Subject: Data Response, Set 2C
Hidden Hills Solar Electric Generating System (11-AFC-2)

Hidden Hills Solar Electric Generating System (HHSEGS)

**Data Response, Set 2C
(Response to Data Requests 147 through 155)**

Figure DR149- 1: Heliostats retinal irradiance – worst case

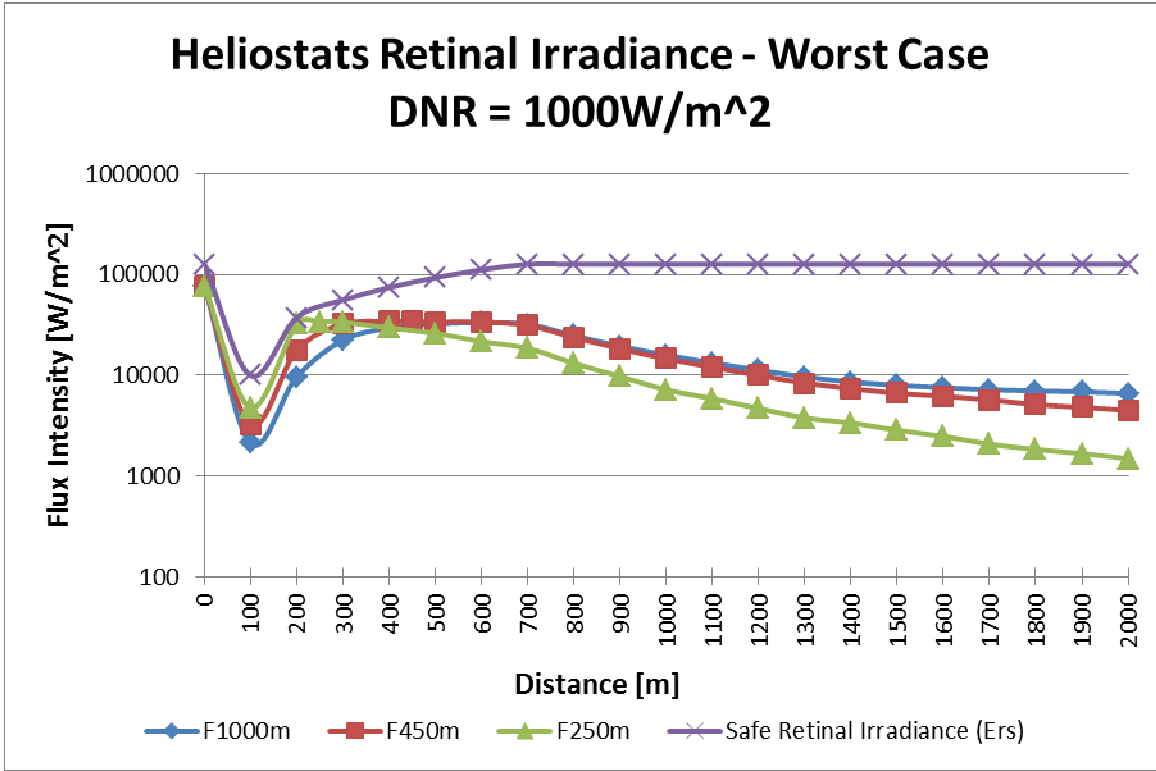
149. Please address the impact of apparent glare and visual disruption for the baseline solar collector dimensions at nominal viewing distance for workers, the public and motorists given the predicted observer incident luminous energy.

There is no safety impact from the heliostats on plant workers since the heliostats' reflection is always below the Safe Retinal Irradiance (E_r), as shown in Figure DR149- 1.

We use the same calculation for the Retinal Irradiance (E_r) from heliostats as we did for the SRSR, using a ray tracing method to model the amount of light concentration at given distances from a given heliostat. In the vicinity of the heliostat the radiation is a single sun reflection; at mid-range distances, the image size is the heliostat reflector nominal size 6.34 m (the diagonal); and for longer distances the image size is the sun diameter 9.3 mrad. For a more accurate calculation we use the relative angle between the viewer and the heliostat, but for safety calculations we considered the worst case ($DNR = 1000 W/m^2$, relative angle is normal to the plane of the mirrors (cosine = 1), no blocking). This case is rare and the nominal impact is at least 30 to 50 percent lower than the described scenario for a single heliostat without blocking.

As can be seen from the ray tracing results in Figure DR149- 2, the beam intensity does not exceed the $4.8 kW/m^2$ and decreases to less than $1 kW/m^2$ after 500 m; the retinal irradiance (E_r) decreases quickly. At all distances the E_r is lower than the safe retinal irradiance (E_{rs}) values (Figure DR149- 1).

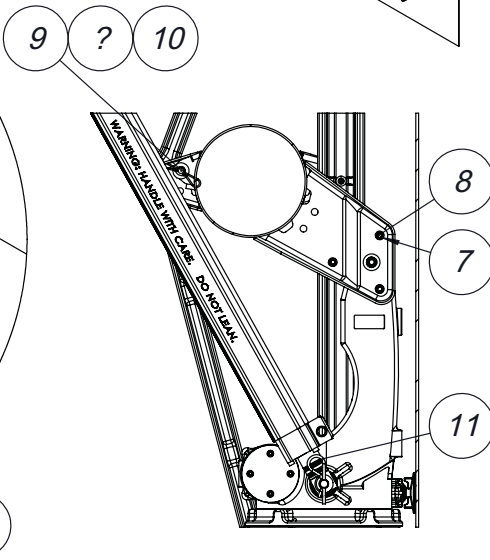
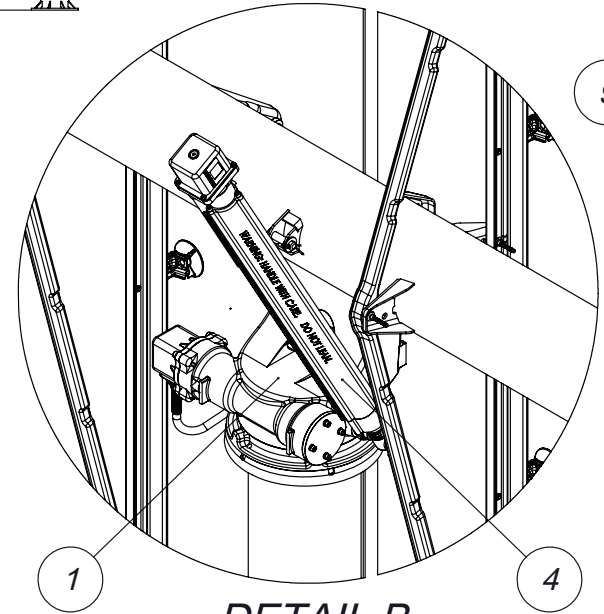
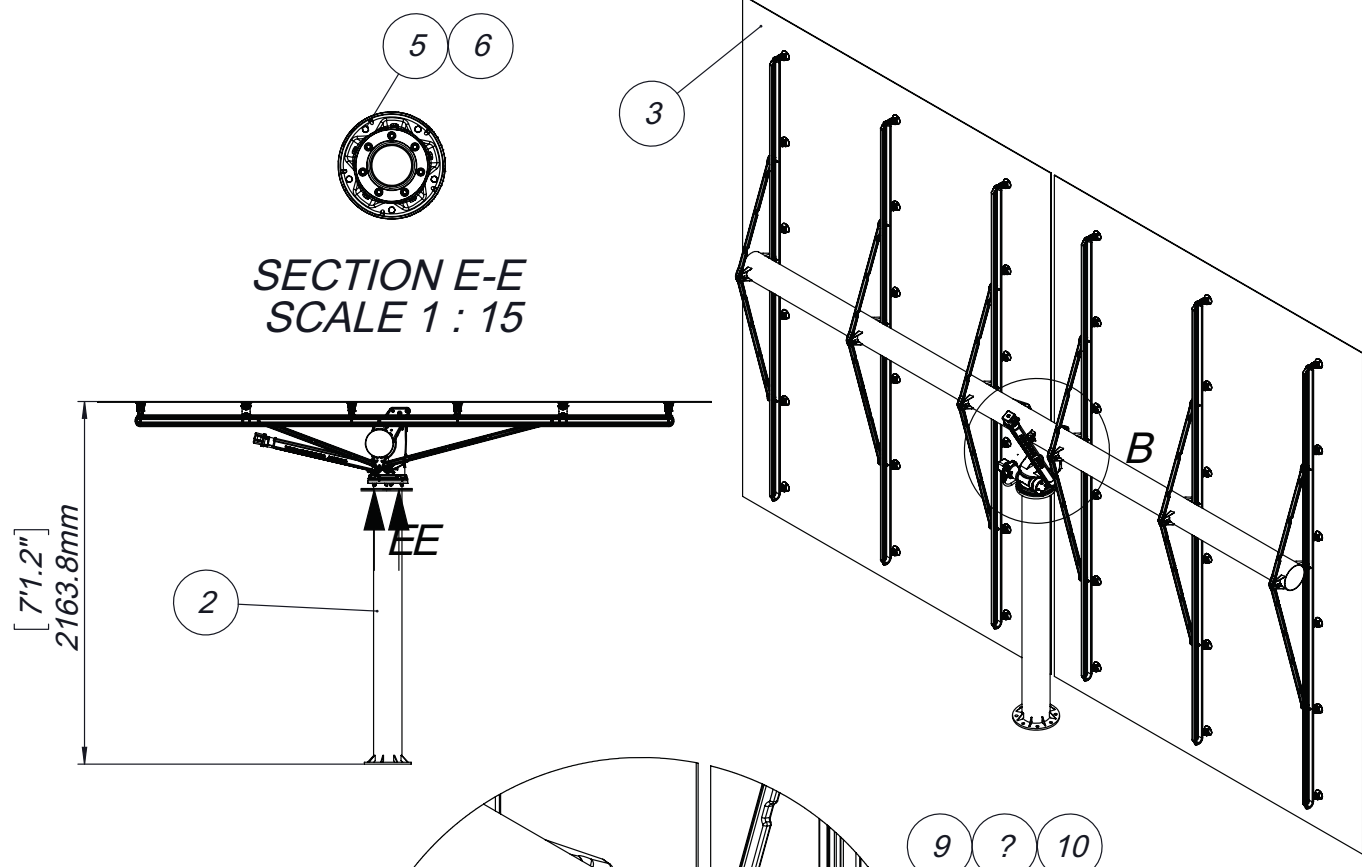
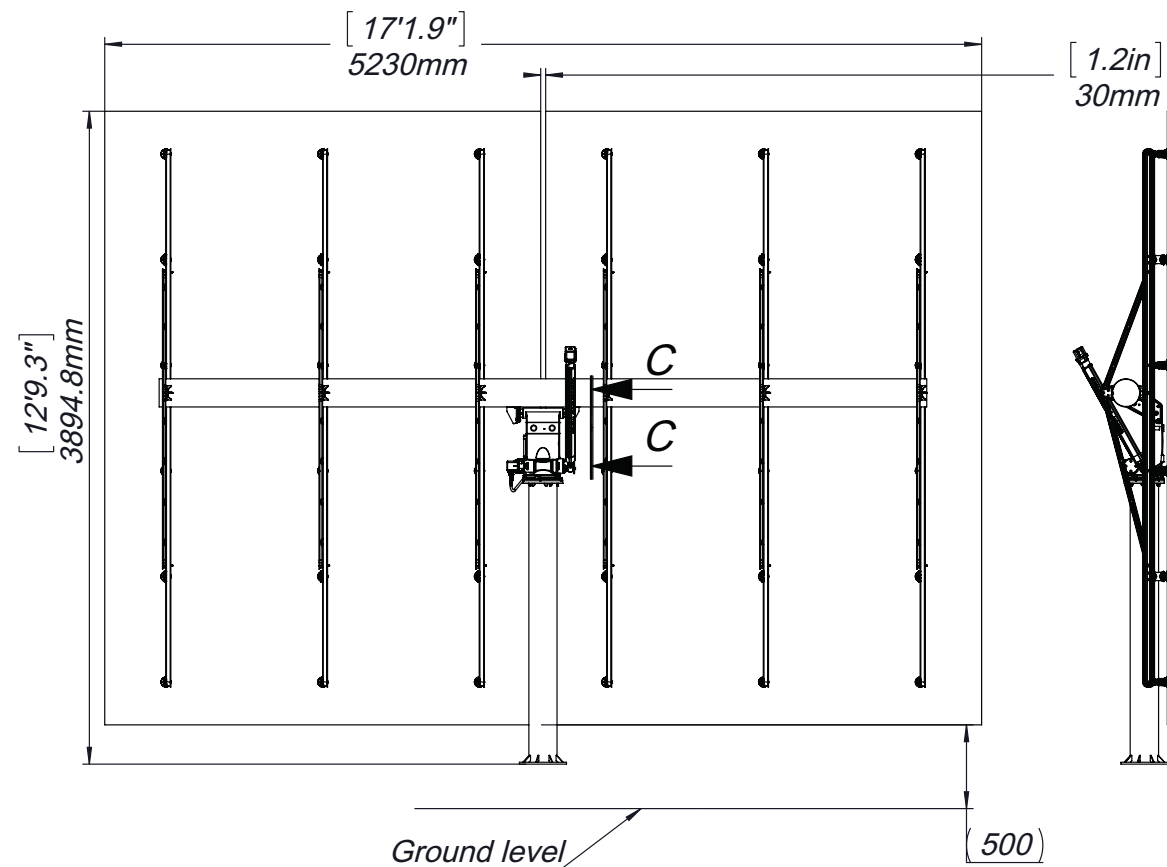
154. Please address the expected frequency and deleterious visual impact of visual scattering effects for visual resources, visual disruption, distraction and glare.

Response: An observer will see the so-called “tee pee effect” (similar to that seen on some cloudy days, of sun rays descending through a hole between clouds—more commonly referred to as the Tyndall effect) at either high relative humidity (RH), e.g., above 40 percent, or during hazy (i.e., dusty) conditions.

What is perceived as converging/diverging light rays is caused by scattering of the sun's light. It occurs when the size of the suspended particulates (generally between 40 and 900 nanometers) is somewhat less than or near the wavelength of the visible light (400 to 750 nanometers).
